# PARTS & SERVICE NEWS

REF NO. AA04145

**SUBJECT:** REPAIR PROCEDURE FOR ABNORMAL NOISE DURING ABRUPT BRAKE APPLICATION

**PURPOSE:** To introduce a modification procedure to repair abnormal noise when abrupt braking is applied on listed wheel loaders.

**PART LISTING**

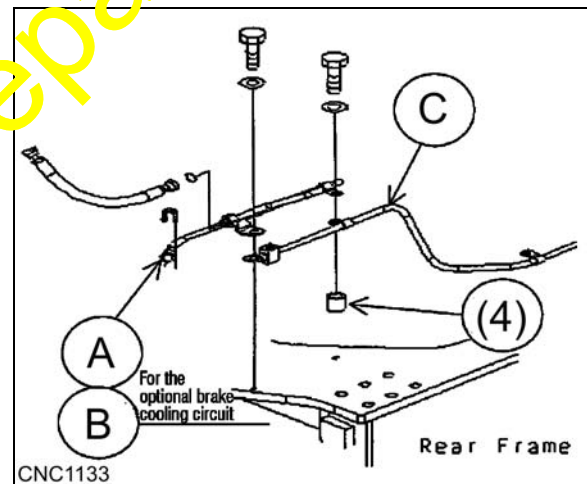
No.	Part Number	Description	Qty.	Remark
1	421-43-37254 (421-43-37253)	TUBE . . . . . (TUBE) . . . . .	1 (1)	
2	421-43-38163 (421-43-38162)	TUBE . . . . . (TUBE) . . . . .	1 (1)	
3	421-U44-3582 (421-U44-3581)	TUBE . . . . . (TUBE) . . . . .	1 (1)	For optional brake cooling
4	421-43-38810 (416-85-52430)	PLATE . . . . . (SPACER) . . . . .	1 (1)	
5	421-43-38820	CHECK VALVE . . . . .	2	
6	02781-00422	UNION . . . . .	2	
7	02896-11012	O-RING . . . . .	4	
8	07002-12034	O-RING . . . . .	2	O-rings listed are to be used when reinstalling the parts. (do not reuse the old O-rings)
9	01010-81025	BOLT . . . . .	1	
10	01643-31032	WASHER . . . . .	1	
11	07002-11423	O-RING . . . . .	2

**DETAIL OF MODIFICATION**

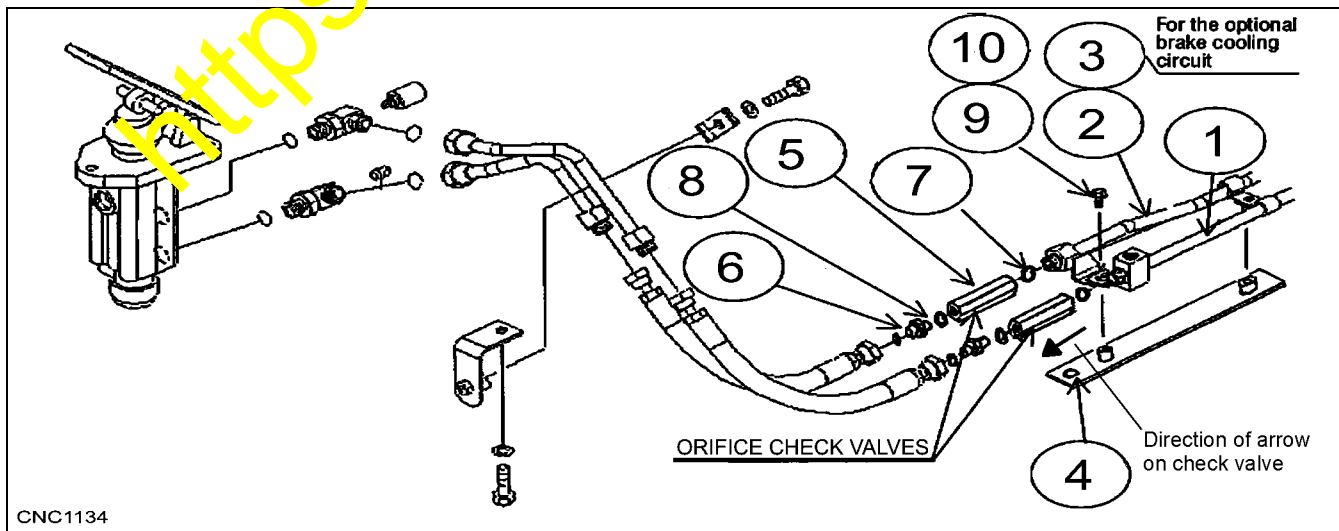
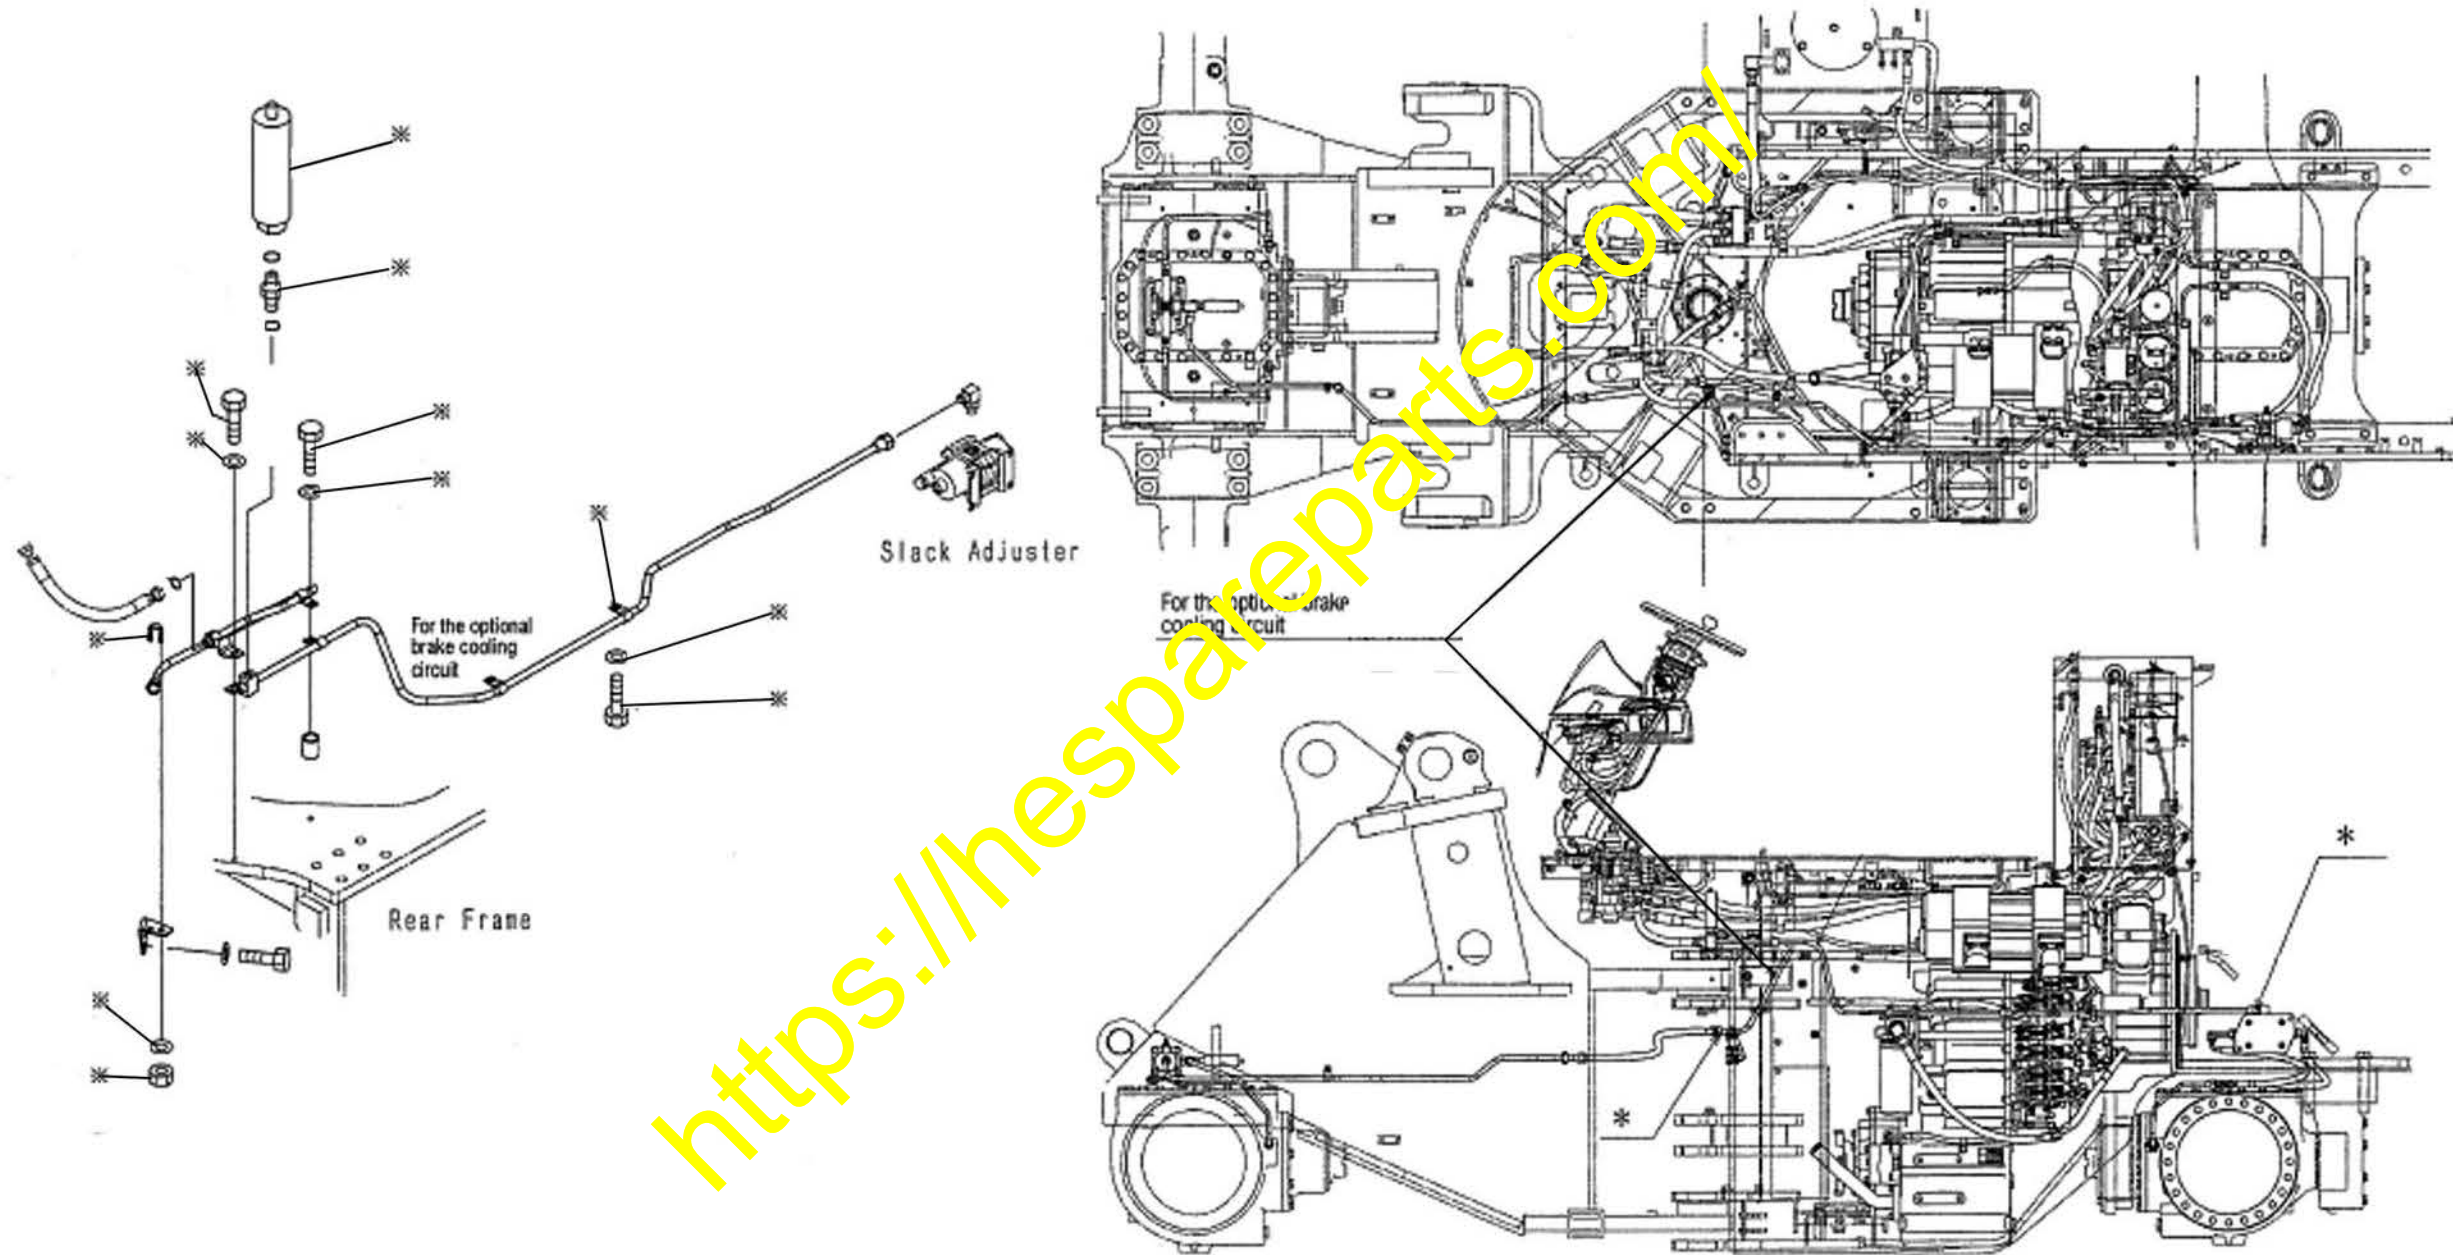
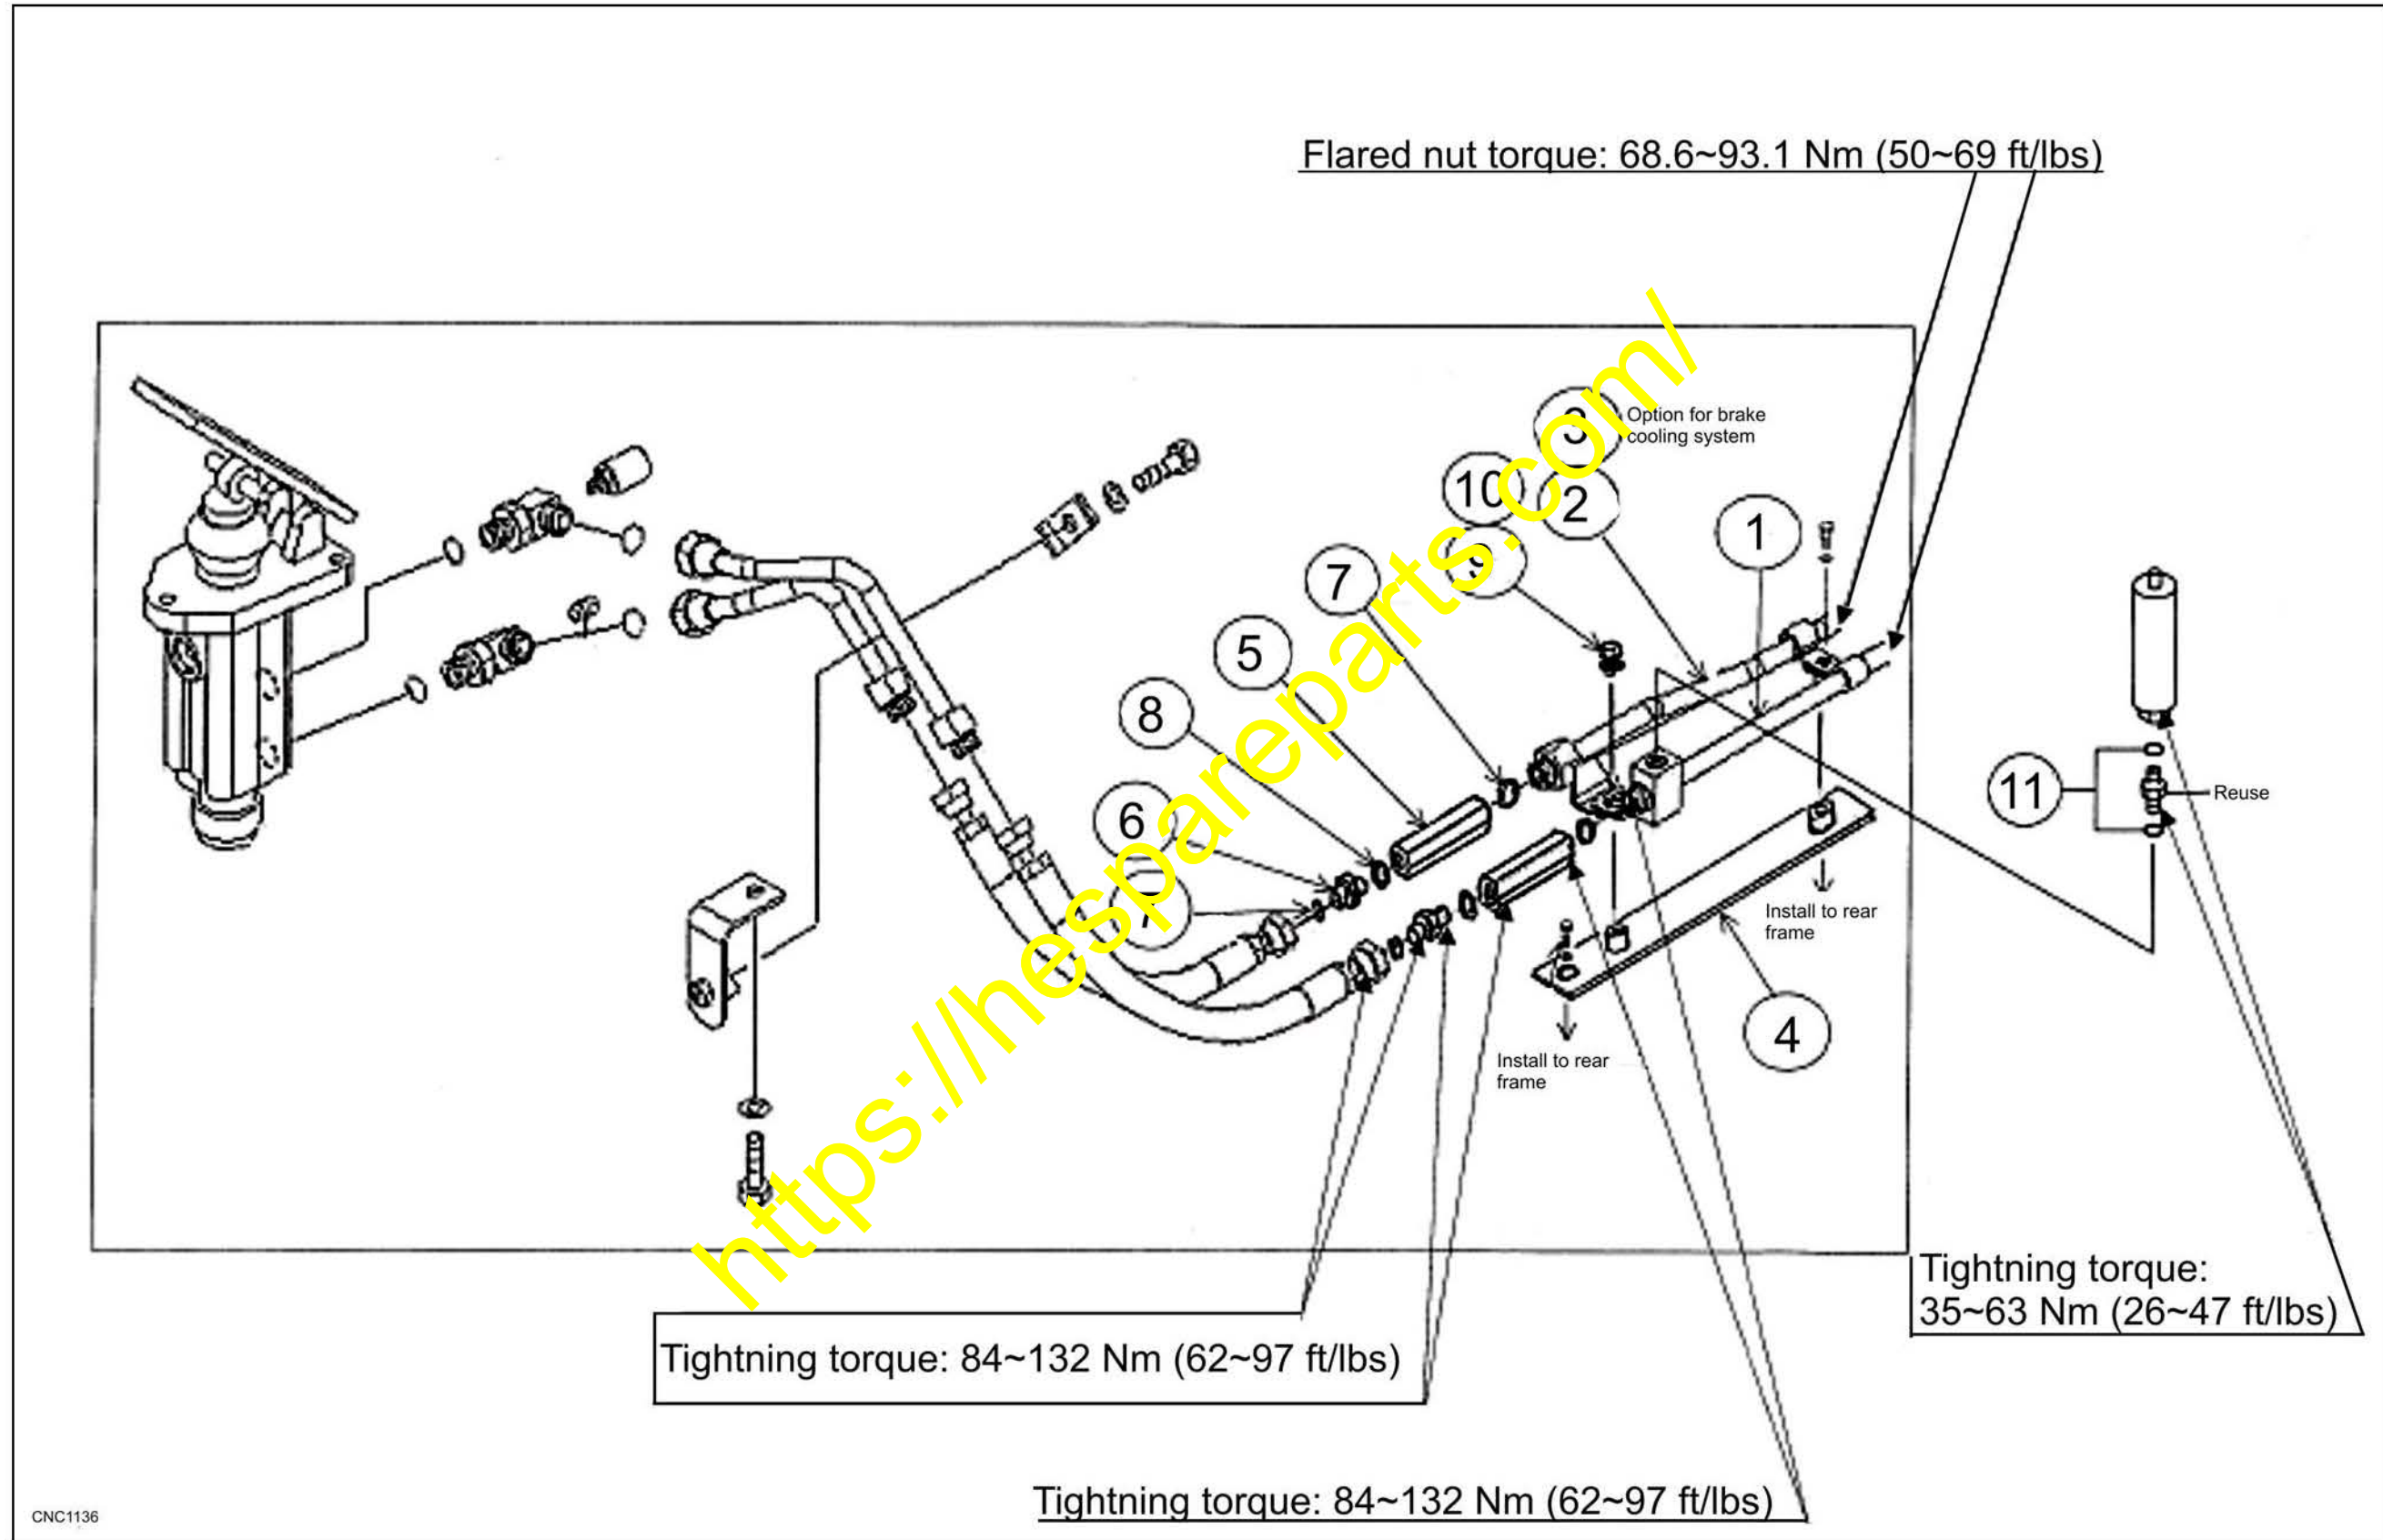
Replace the tubes (A,B and C) with the new improved parts and add the slow return valve.

- a. 421-54-37253
- b. 421-43-38162
- c. 421-43-38820

• The parts marked \* will be reused after their removal.
